Technical Evaluation Report

For the Revised Performance Assessment
for the Saltstone Disposal Facility at the
Savannah River Site, South Carolina

U.S. Nuclear Regulatory Commission
Office Of Federal And State Materials
And Environmental Management Programs
Washington, DC 20555-0001

APRIL 2012

Figure 2.7-1: Vertical Darcy velocity through saltstone in Vault 4 predicted with the DOE PORFLOW™ model. Data for the Synergistic Case excludes fractures (other cases do not represent fractures explicitly). Data taken from DOE's STAT.out files (NRC, 2010g).

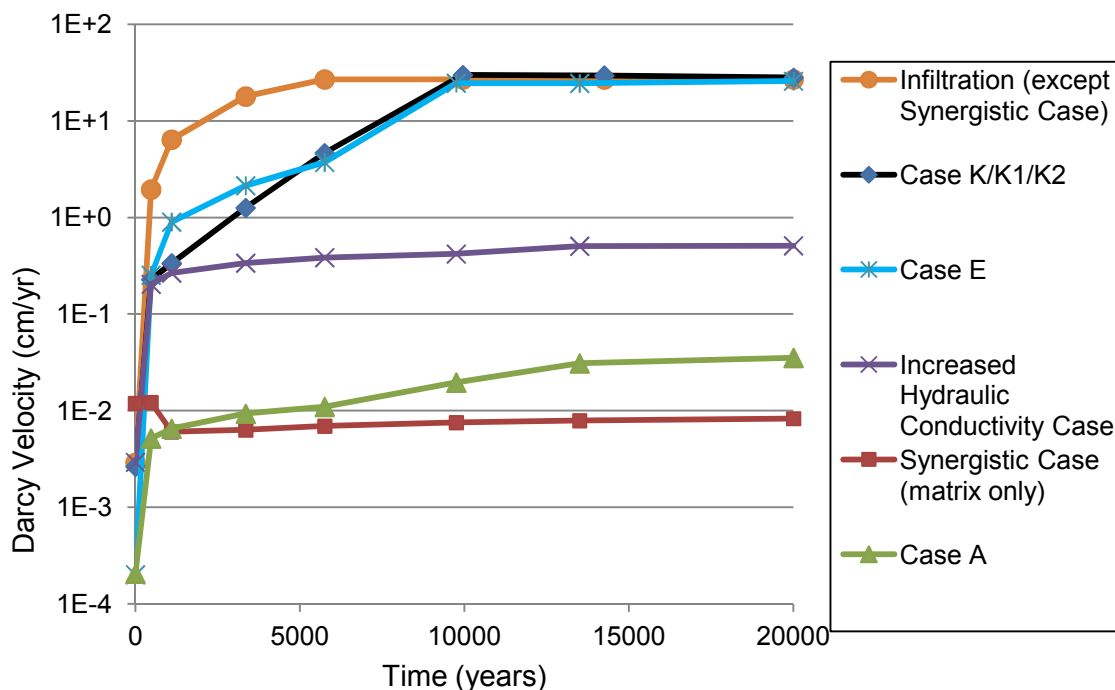
As discussed in more detail in Sections 2.5 and 2.6, the NRC staff found that the assumed low hydraulic conductivities of saltstone and the disposal unit concrete used in Case A and many of the deterministic sensitivity cases were overly optimistic. Similarly, assumptions regarding the performance of the lateral drainage layer, the disposal unit roofs, and the HDPE/GCL layer (for the FDCs) resulted in a significant amount (i.e., greater than 99% of the infiltrating water being shed around the disposal units even 10,000 years after site closure in Case A and several of the deterministic sensitivity analyses (Section 2.5) (SRR-CWDA-2011-00044; IEC-8). As discussed in Sections 2.5 and 2.6, the NRC staff finds that Cases K, K1, and K2 more realistically represent the current and expected future hydraulic and physical properties of the saltstone and disposal units. In these cases, the modeled flow through the saltstone and disposal units does not appear to be inappropriately constrained (Figures 2.7-1, 2.7-2, and 2.13-1).

With respect to flow modeling, the NRC's analysis of DOE's near-field model indicates that Case A appears to severely constrain flow through saltstone (Figures 2.7-1 and 2.7-2). As discussed in detail in Section 2.6, the saltstone hydraulic conductivity that contributes to this low flow value is inconsistent with recent measurements and does not reflect any degradation of the hydraulic conductivity as the saltstone ages. Flow through the saltstone and disposal unit concrete in the PA Cases (i.e., cases other than Cases K, K1, and K2) were further limited by moisture characteristic curves that are inconsistent with curves found in the literature for similar materials. DOE demonstrated that the effect of the suspect moisture characteristic curves is limited to a factor of 2 in Case A (Section 2.7.3), however, the effect may be greater if other engineered barriers do not perform as modeled. Because of the large uncertainty in the potential degradation of saltstone, disposal unit concrete, and the HDPE/GCL layers on the FDCs, and because of the importance of these barriers to system performance (Section 2.13), the NRC staff will monitor the development of model support for the long-term performance of these materials.

Figure 2.7-4: Characteristic curves for the intact and fractured saltstone and concrete as adapted from the 2009 PA and SRNL-STI-2009-00115 (SRR-CWDA-2010-00033; Figure 2)

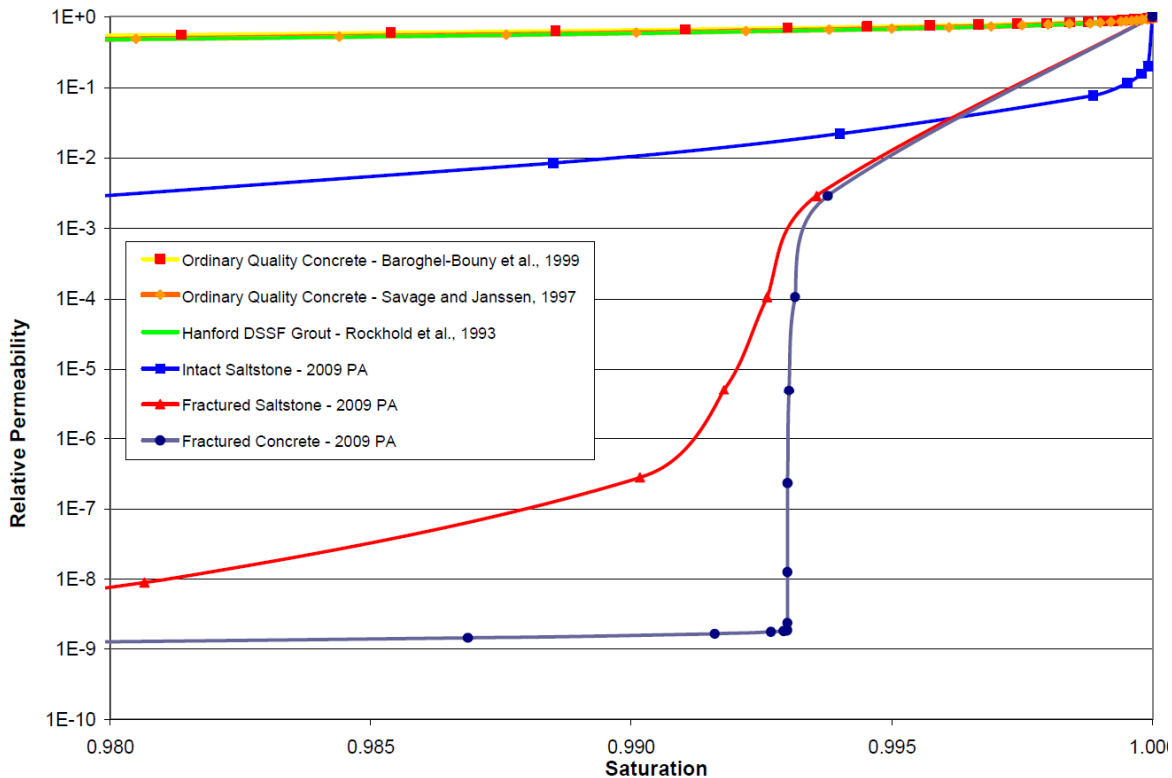
However, as NRC indicated in response to these DOE analyses (NRC, 2010j; SP-3), one-off sensitivity analyses may result in insignificant increases in the dose on an absolute basis; however, the effect on dose results may be significant when there are many outstanding uncertainties that are evaluated on a cumulative basis. In response to the second RAI (SRR-CWDA-2011-00044), the DOE provided a more comprehensive analysis, Case K, to address the NRC staff's concern with DOE's moisture characteristic curve for intact saltstone as well as other concerns. In this analysis, DOE fixed the relative permeability to one for the cementitious materials (i.e., moisture characteristic curves were not used). NRC staff finds that this approach is reasonable due to the (i) uncertainty in unsaturated flow through cementitious materials over long periods of time and (ii) limited amount of reduction in flow that would be expected for cementitious materials that are predicted by DOE to be near saturation. Case K also addressed NRC staff's concern with the moisture characteristic curves that were used to represent unsaturated flow through fractured saltstone and concrete.

DOE used an analytical approach to develop curves for fractured cementitious materials in the PA based on the moisture characteristic curves that were to represent intact saltstone. Figure 2 of the first RAI response (SRR-CWDA-2010-00033) shows the curves for fractured saltstone (used to represent the saltstone grout in Case E) and fracture concrete (used to represent the walls of Vaults 1 and 4 in all of the cases in the PA except the Synergistic Case) (Appendix E of SRNL-STI-2009-00115; SRR-CWDA-2010-00033). The figure illustrates that a decrease in the saturation of the walls of Vaults 1 and 4 from 100% to 99% results in an unrealistic decrease of nine orders of magnitude in relative permeability. The NRC staff's concern, as discussed in the

Figure 2.8-8: Locations of Sources at the Saltstone Disposal Facility (2009 PA, Figure 4.2-20)

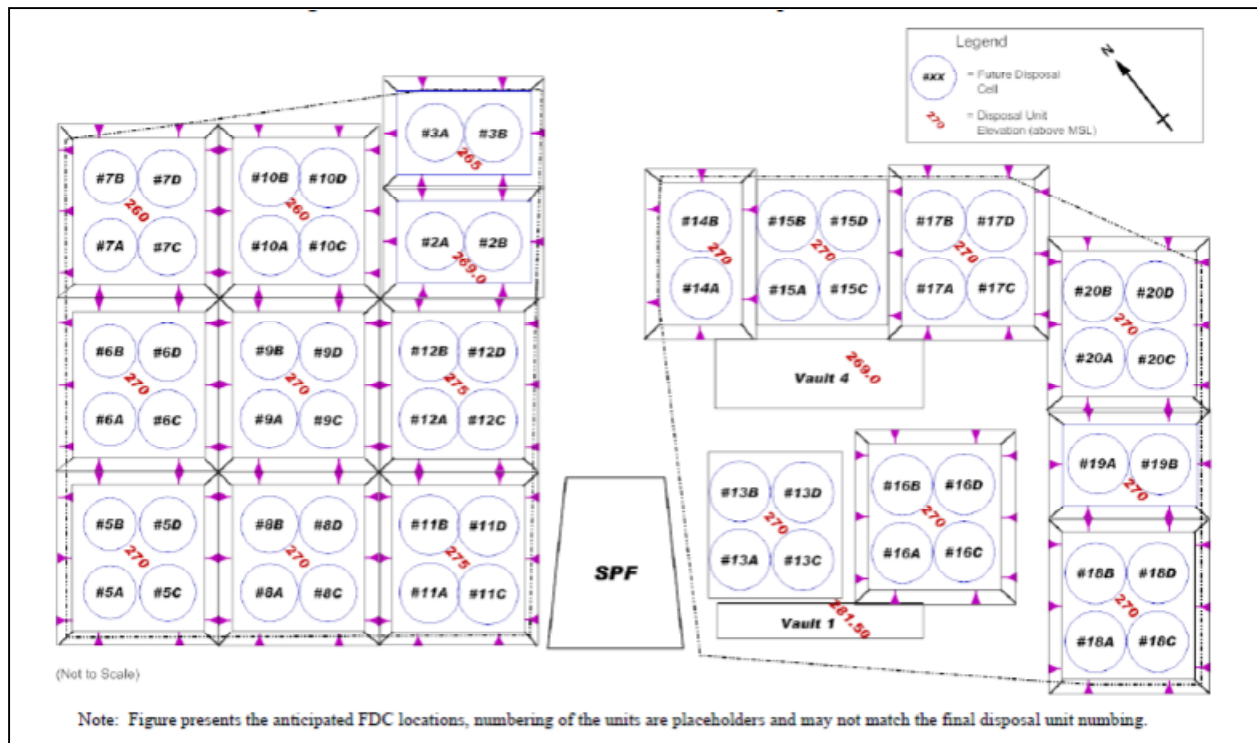
NRC staff attempted to evaluate the contributions of various sources to the peak dose in Case K. Although NRC staff used an earlier version of PORFLOW™ (v 6.12.3) that is not able to specify vertical dispersivities separately and the sources simulated may not contribute to the exact point in the UTR aquifer that the peak Case K dose in DOE's SDF/PORFLOW™ model occurs from all sources, the results should provide a relative indication of individual source (or source group) contributions to dose at the 100 m boundary. Table 2.8-4 presents the results of this evaluation. Figure 2.8-8 illustrates the source locations simulated at the SDF.

Figure 2.13-4: Water shedding around Vault 4 in DOE Case A at 0 and 8,000 years after site closure (left top and bottom) as compared to an NRC interpretation of known conditions (top right) or potential future conditions considering uncertainty (bottom right)

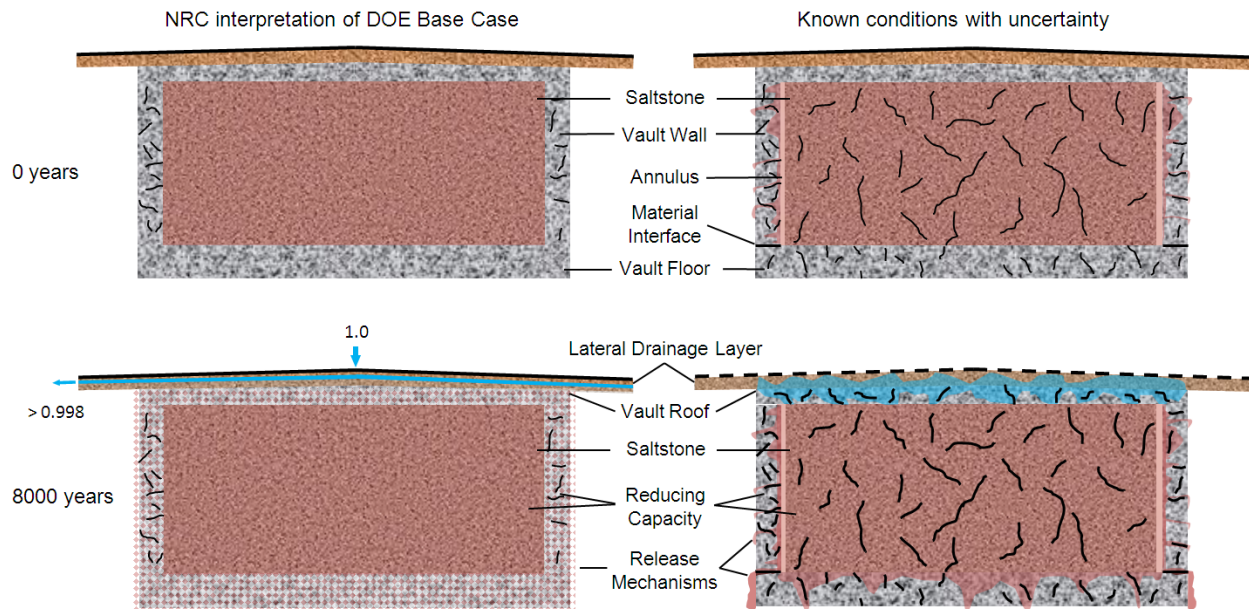
drainage layer, demonstrates the importance of the large contrast between the modeled hydraulic conductivity of the lower lateral drainage layer and the layers it overlies above each disposal unit (i.e., the roof for Vault 1 and 4, the HDPE, geosynthetic clay liner, and roof for the FDCs).

saltstone has been released from the saltstone and re-concentrated in the disposal unit concrete (Figure 2.13-4). Because the disposal unit floor and walls have a much lower volume than the saltstone, this process, as modeled, would result in a 13-fold increase in the original Tc concentration in saltstone. This unexpected behavior occurs because the disposal unit floors and walls are modeled with much higher K_d values than saltstone as saltstone becomes more oxidized (e.g., at 10,000 years after closure, saltstone is modeled with a K_d of 0.8 mL/g as compared to the FDC floor at 406 mL/g, FDC walls at 388 mL/g, Vault 4 floor at 388 mL/g and Vault 4 walls at 228 mL/g) (Section 2.7). The NRC staff does not believe this modeled behavior is realistic because (1) the disposal unit concrete is expected to have about 40% of the specific reducing capacity of saltstone because of its lower blast furnace slag concentration; (2) the disposal unit floors and walls are more exposed to environmental conditions than saltstone is and would be expected to fracture within 10,000 years; (3) water flowing through fractures in the disposal unit floors and walls would be expected to create oxidized conduits in which Tc is not expected to be re-reduced and immobilized after release from the saltstone, and (4) water may flow out of the disposal unit through joints and consequently may not interact significantly with the disposal unit concrete.

Figure 2.13-7 Intermediate results from DOE PORFLOW™ model for Case K, showing Tc release from Saltstone and re-concentration in the FDC floor and walls. At approximately 13,000 years after closure, over 90% of the Tc inventory originally in saltstone is present in the FDC floor and walls.

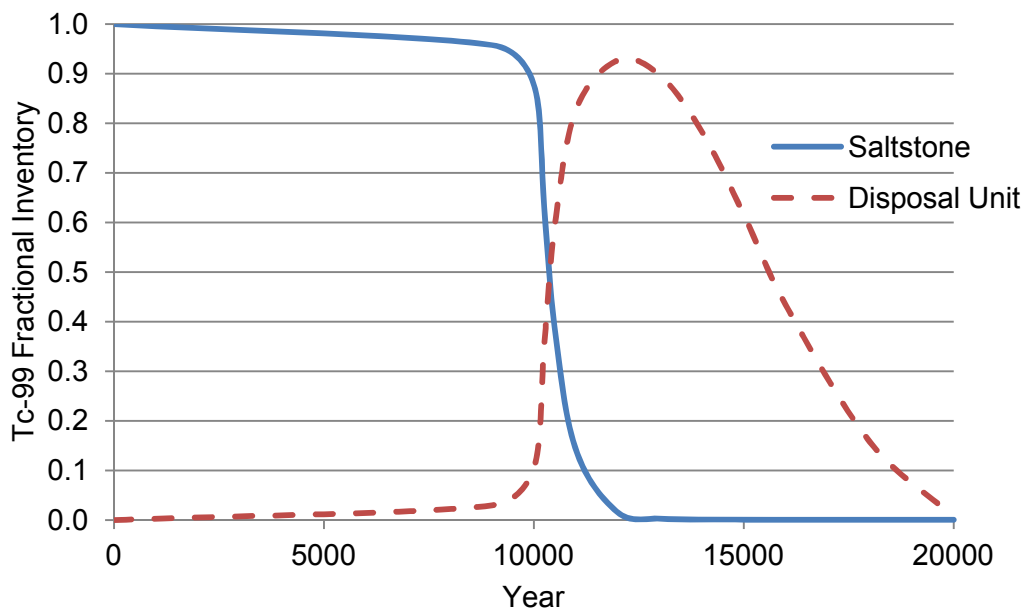
The two primary effects of this re-concentration in the disposal unit floor and walls are to delay the peak dose by approximately 5,000 years and to significantly reduce the magnitude of the peak dose. Peak doses are reduced because the peak dose is very sensitive to the rate at which Tc is released into the environment, and the modeled Tc release from the disposal units is much slower than the modeled Tc release from the saltstone.

Comparison of the simple average- K_d and dual- K_d models indicates that the average- K_d model can under-predict releases in the short-term and significantly over-predict peak release rates in some cases (Figure 2.13-5). The NRC staff calculations indicate the average- K_d model over-predicts release rates most significantly in cases in which most of the release comes from the oxidized, rather than the reduced, fraction of saltstone. Thus the effect is most pronounced when there is relatively low water flow through saltstone to release Tc from the reduced region before significant oxidation occurs. Comparison of model results indicates that the dual- K_d model allows a more gradual release of radionuclides, resulting in a smaller available inventory at times when the average- K_d model would predict nearly the entire initial inventory is released with a relatively low average sorption coefficient. This result is similar to the result of DOE's comparison of an average- K_d model and a dual- K_d model (which DOE refers to as single- and dual-porosity models) (SRR-CWDA-2011-00114), although the NRC staff's simplified models predicted a more substantial difference between the two approaches than predicted by DOE. The magnitude of the overprediction of peak dose that both NRC and DOE expect the average- K_d model to cause is unclear. DOE's conclusion that the average- K_d model provides a good representation of Tc release is based on a comparison of two GoldSim® models rather than a comparison involving the actual PORFLOW™ model DOE used to model Tc release. NRC staff concluded DOE's GoldSim® comparison was likely to underestimate the difference between the models, as compared to a similar comparison performed in PORFLOW, because of certain implementation details in DOE's GoldSim® models (Section 2.7). However, the DOE models include diffusion between the oxidized and reduced regions, which is an important process not included in the simplified NRC staff models. In DOE's Case K, K1, and K2 analyses, the expected over-prediction of peak dose attributable to the average- K_d model is further obscured by the re-concentration and gradual re-release of Tc from the disposal unit floor and walls (Figure 2.13-7).
